**Chemung County Stormwater
Construction Inspection
Erosion and Sediment Control**

Project Name Barrington West Lot 54	Date 12-16-2021
Location Royal Crest Horseheads (T)	Permit # NYR11F212
Weather Conditions sunny	Entry Time: 10:22 am
On-Site Representative Present: none	Exit Time: 10:30 am

PROJECT: Barrington West Lot 54
Town of Horseheads
Municipal Construction Inspection
December 16, 2021

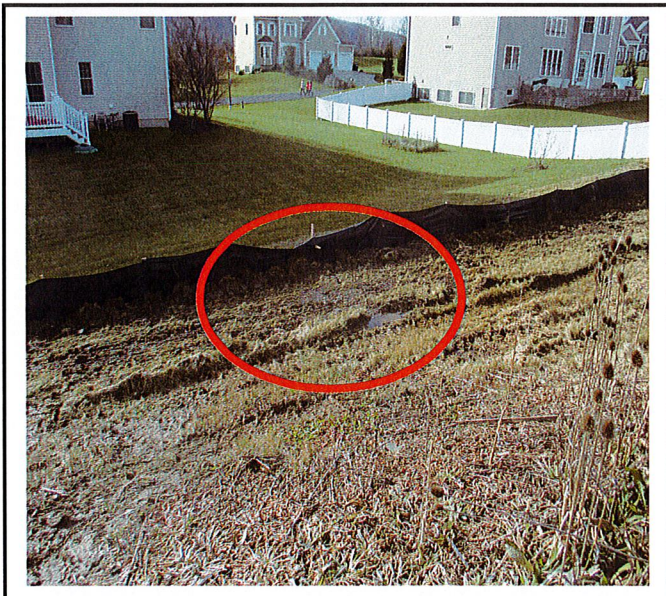
Silt fence installed and functioning.

Keep an eye on this spot. It appears that drainage is concentrated here and could cause issues.

Construction entrance installed but need driveway permit from the Town.
